LINCOLN PARK PLANNING COMMISSION
CITY HALL – COUNCIL CHAMBERS 1355 SOUTHFIELD ROAD
LINCOLN PARK, MICHIGAN

There are no proposed changes to the site plan since the Planning Commission last approved it, with the exception of a minor boundary change which was approved administratively in March 2017. For the required Conceptual Review, the Commission is asked to consider the previously approved plans and analyses, which have been included in this packet.

River's Edge Apartments Site Plan Review

PAVING AND GRADING PLAN
26182 OUTER DRIVE, CITY OF LINCOLN PARK, WAYNE COUNTY, MICHIGAN

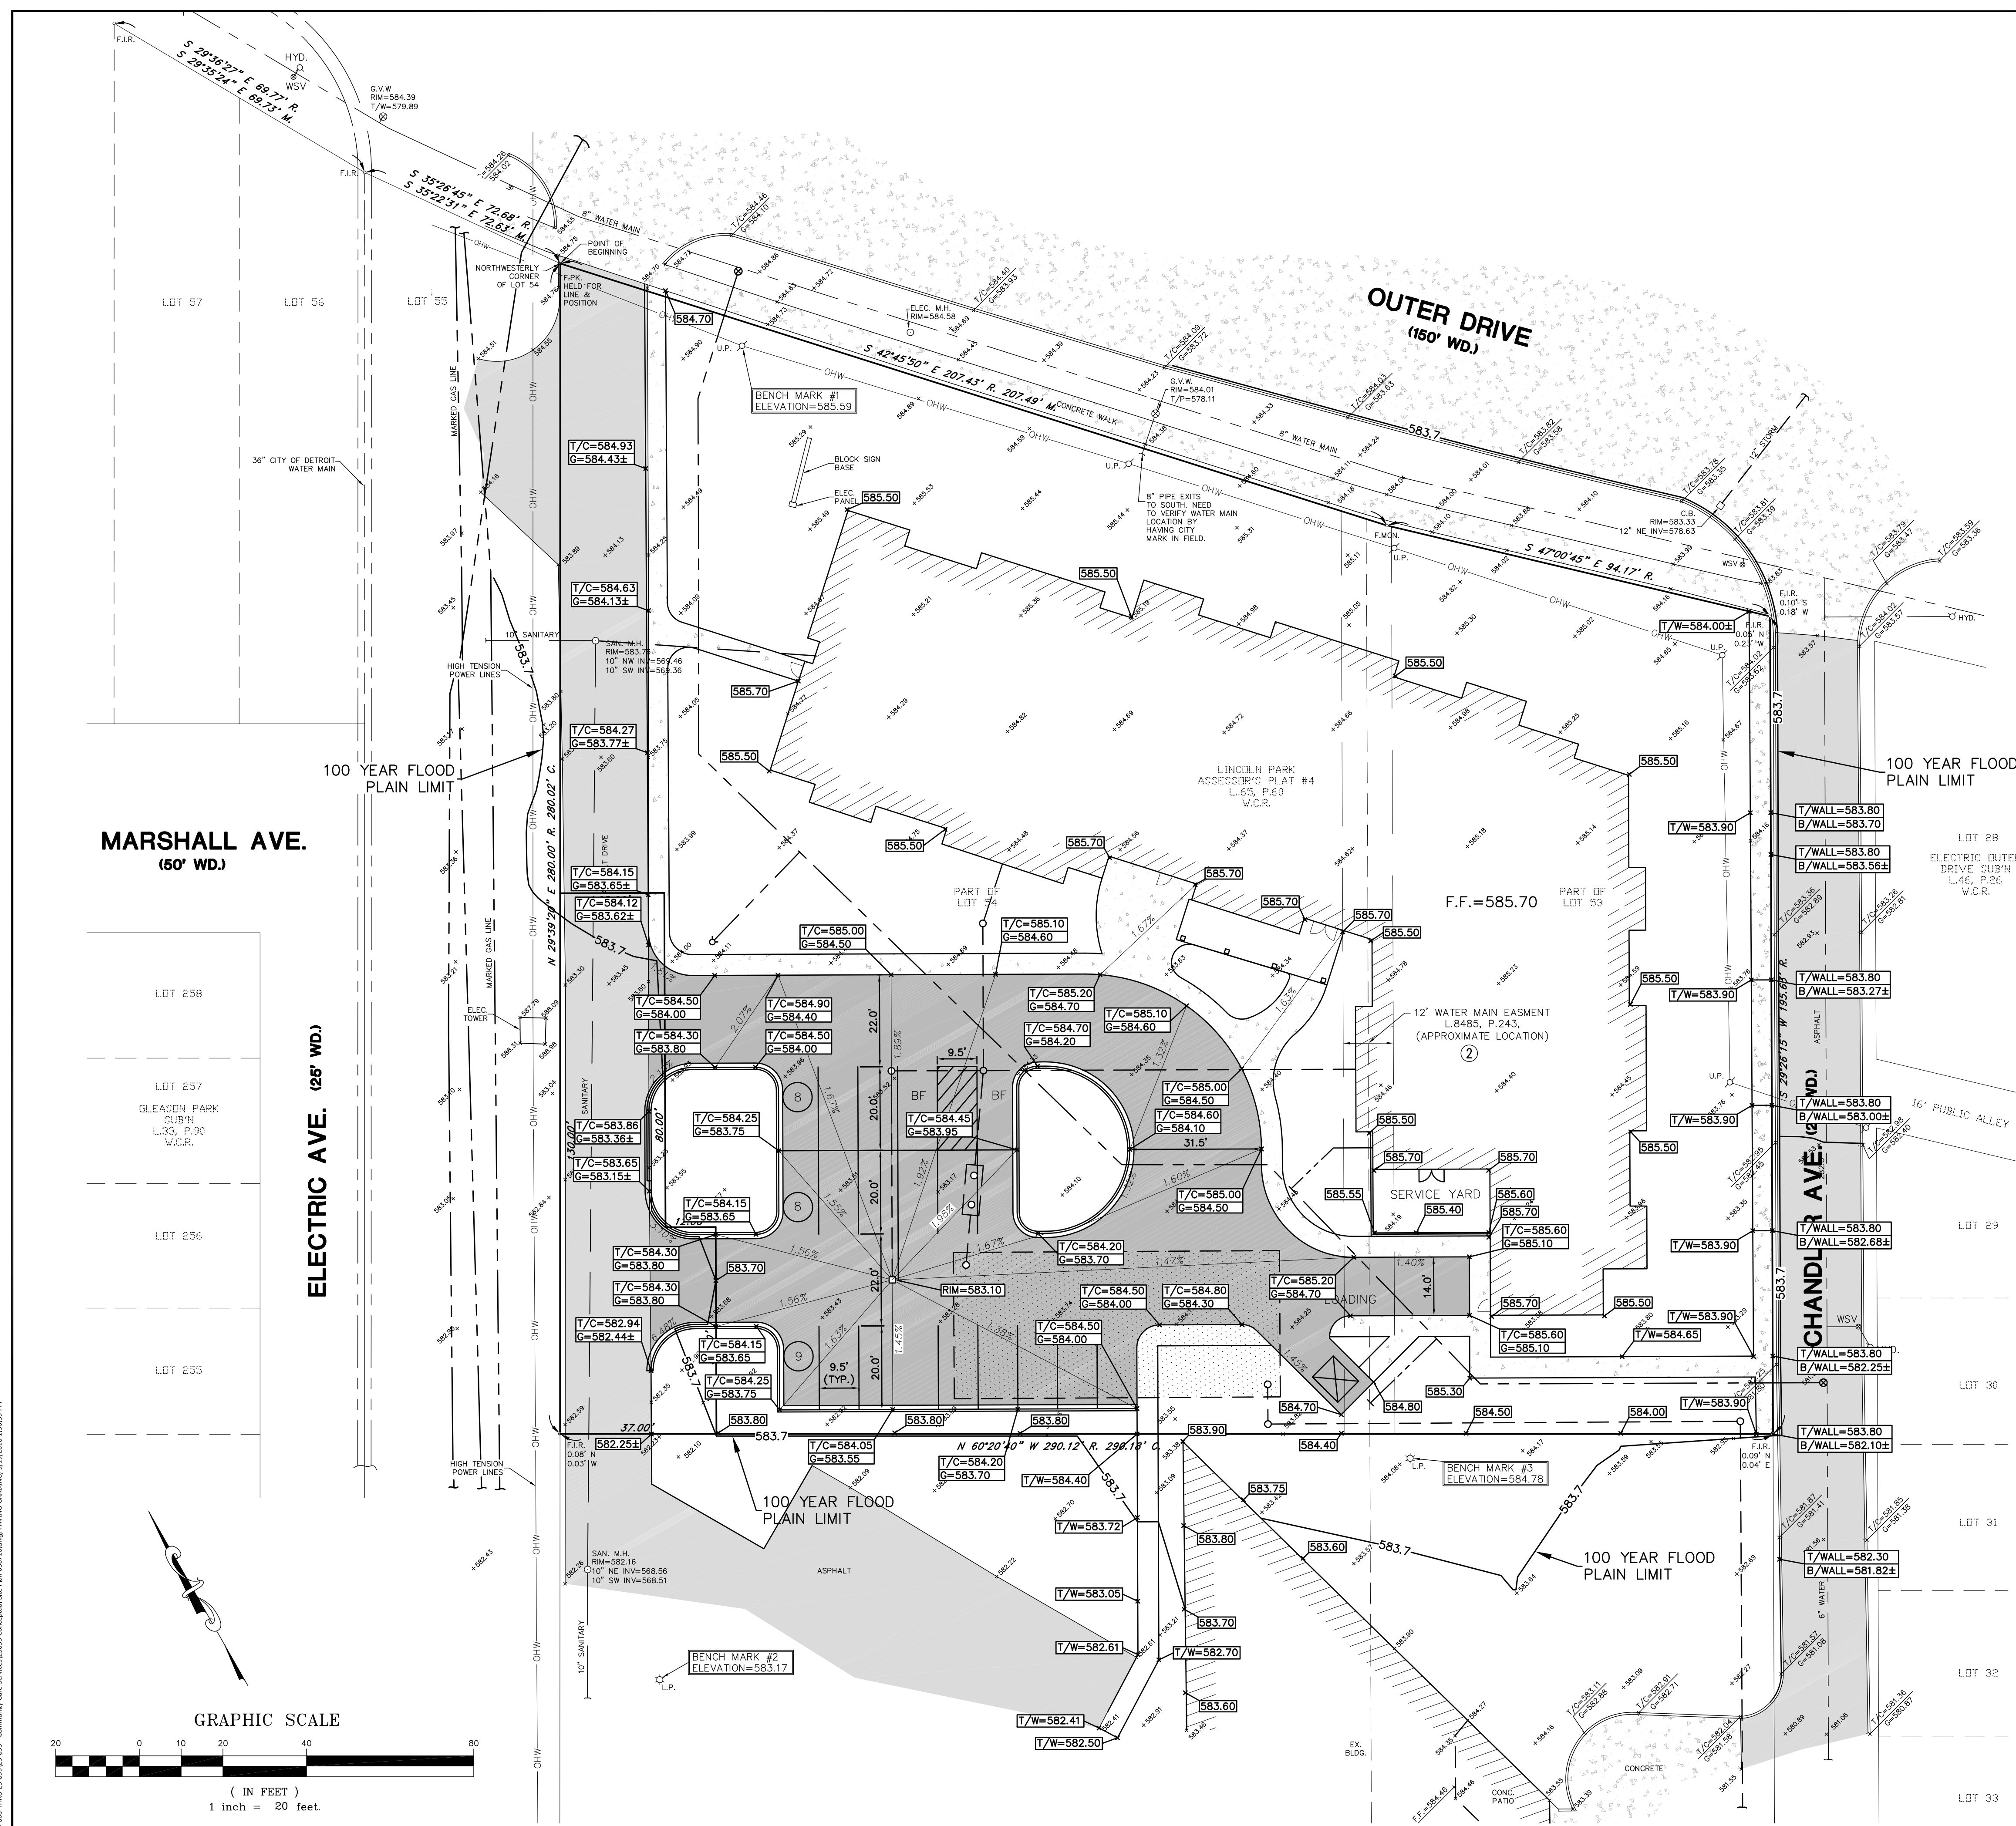
- *Applicant to show percent slopes on parking lot grades*

Sheet C2 – Paving and Grading Plan has been revised to show that the entirety of the parcel (with the proposed removal of the 3,850 square foot area in the southwest corner) will be above the 100-year floodplain elevation of 583.70.

Sheet C2 - Paving and Grading Plan has been revised to include percent slopes for the proposed parking lot grades.

SITE PLANTING PLAN

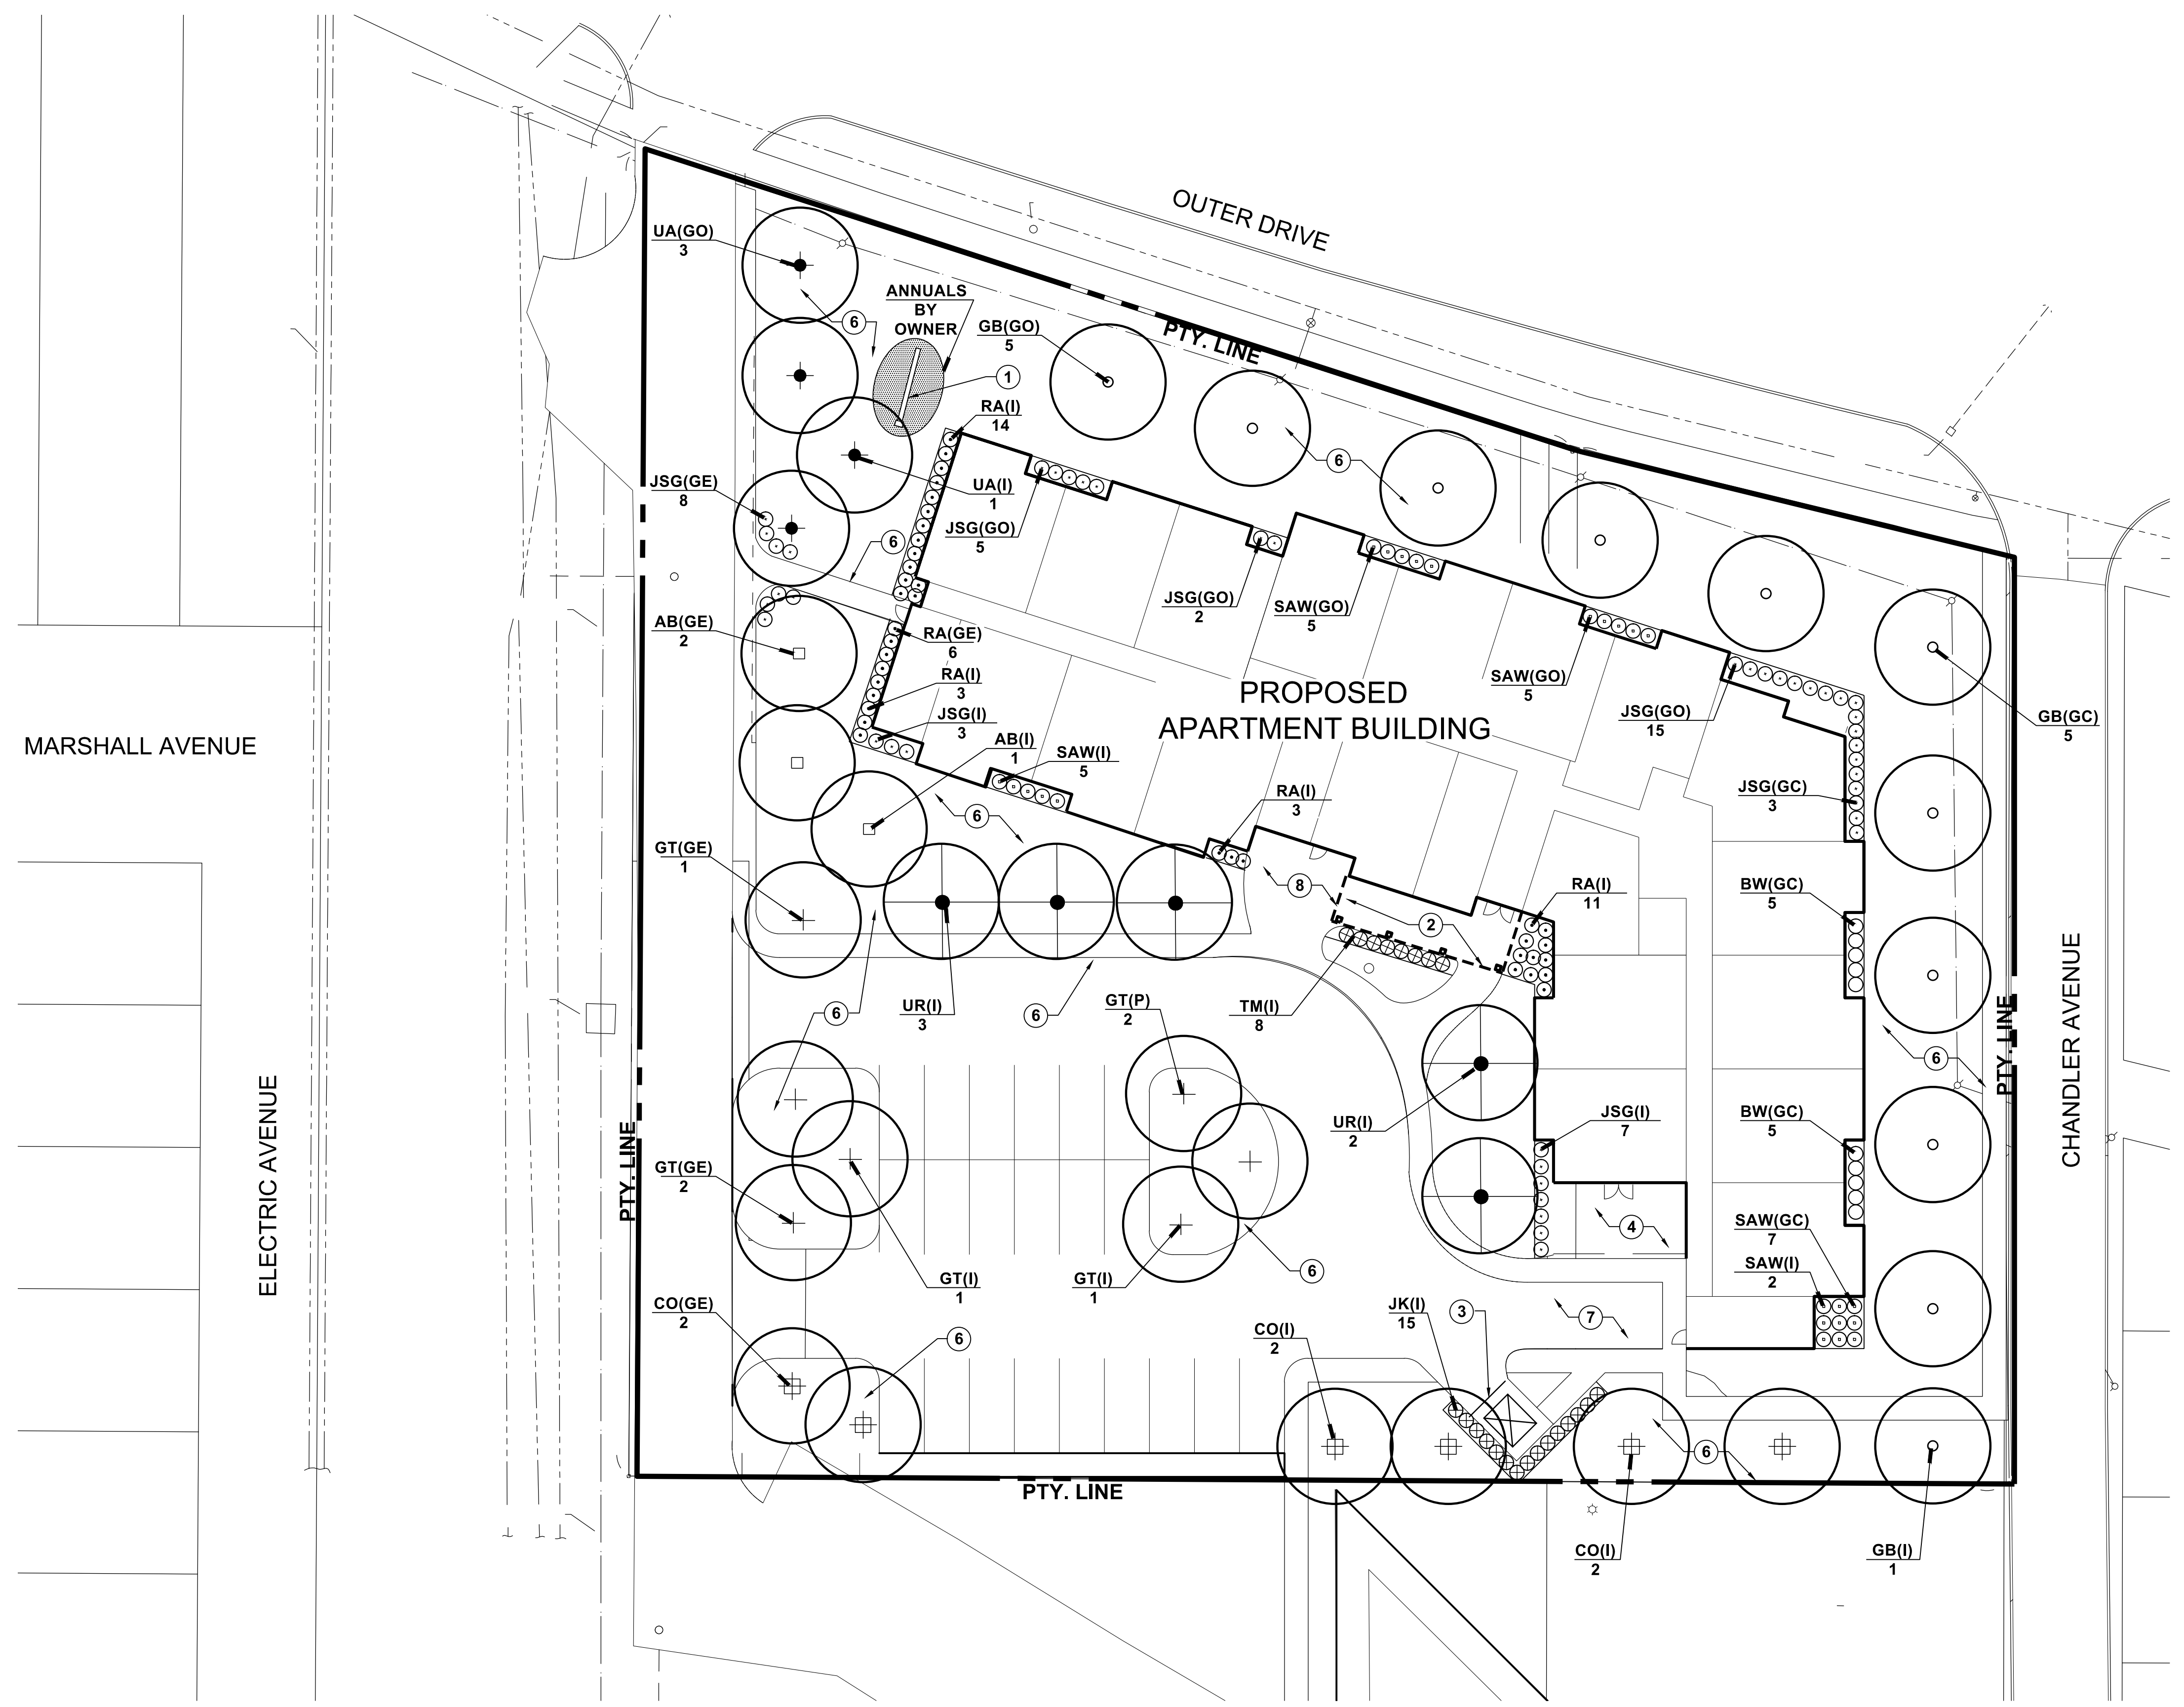
- *7 additional trees and 6 additional shrubs shall be added to landscaping plan.*

Sheets L.101 and L.102 have been revised to include 7 additional trees and 6 additional shrubs.
